## How to make your new Micro Magic 2014.V2 class-legal

The official Graupner denomination is V2 for version 2.

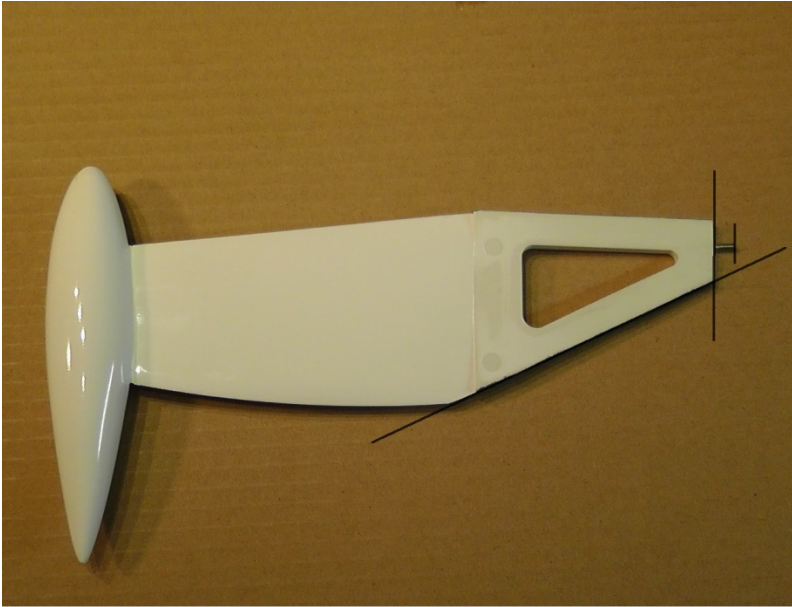
The keel (RTR includes the classic fin version) goes too deep, e.g. 138mm instead of max. 135mm.

The keel is also too heavy, about 430 gram instead of max. 420 gram.

Drill a hole in the bomb and fill up with lightweight material. Sand or cut the tongue as shown in the picture.

You might want to remove the keel bomb's plastic cover first and do your own filling and fairing.

Make sure that the keel weighs no more than 420 gram and is no longer than 135 gram

### KIT

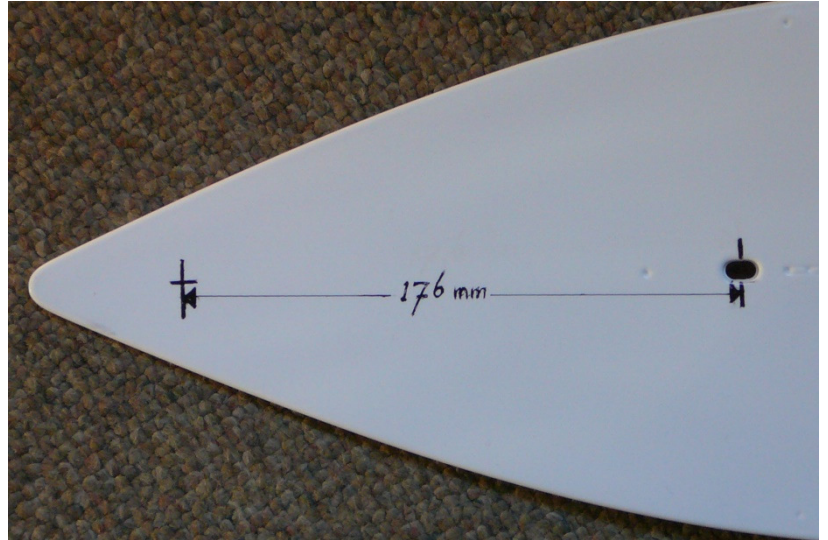
- Jib-attachment  
The mark in the deck for the jib-attachment is wrong. It should be **176 mm** from the middle of the mast-position, as shown in the picture.

- Rudder position  
There is neither a hole nor a mark in both hull and deck. It should be **210 mm** from the back-side of the keel-trunk, as shown in the picture.
